**OXFORDSHIRE COUNTY COUNCIL RESPONSE
ON WATER RESOURCES CONSULTATION
DRAFT REGIONAL PLAN FOR THE WEST
Consultation closing date: 20th February 2023**

1. Oxfordshire County Council is responding to the following consultations:
 - Water Resources West (WRW) draft regional plan consultation¹ (this response)

Figure 1: Map of Grand Union Canal Transfer³

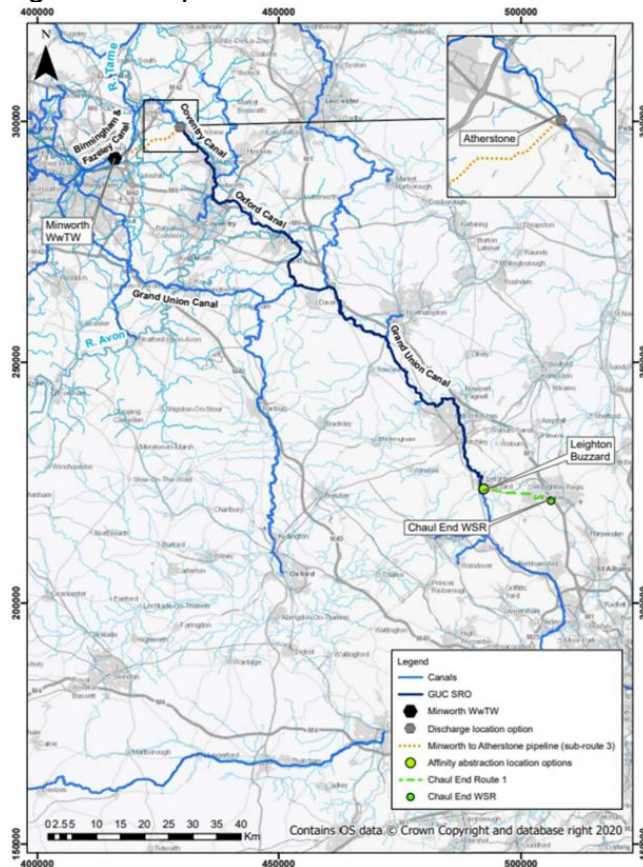
5. The GUC scheme now involves transferring water from Minworth wastewater treatment works in the West via the Coventry Canal, Oxford Canal and Grand Union Canal to Affinity Water in the South East, supplying Affinity Water customers with up to 50MI/d from 2031 and a further 50MI/day by 2040 to 2050.

7. Elements of the Grand Union Canal would be upgraded as part of this, for example increasing canal bank and towpath levels at certain locations, and there would be new pipeline connections at either end.

8. The option sensibly uses an existing canal resource to get water from the Midlands to London. It is understood that the option is supported by the Canal & River Trust and there would be benefits from upgraded facilities, flood alleviation, habitat creation etc.

12. Oxfordshire County Council supports the GUC proposal.
